PREPARED	NAME L. Pazmany	May 10-73	PAZMANY AIRCRAFT CORPORATION SAN DIEGO — CALIFORNIA	MODEL NO.	PL-4A
CHECKED			ENGINEERING CHANGE NOTICE # 2	REPORT NO.	
APPROVED				PAGE NO.	1

DWG. 4-30-010 - FRAME STA 70.36. (MANDATORY CHANGE). ERROR IN DWG.

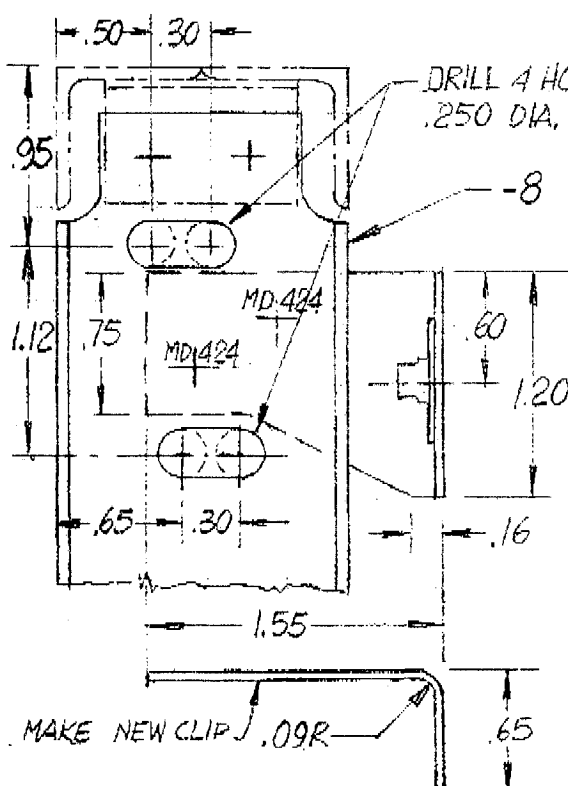
RELOCATE HOLES FOR TRIM CONTROL CABLE AS SHOWN. DELETE CLIP 4-30-003 -39. MAKE A NEW CLIP AS SHOWN. MATERIAL: 2024-T3-SHEET .040 THICK.
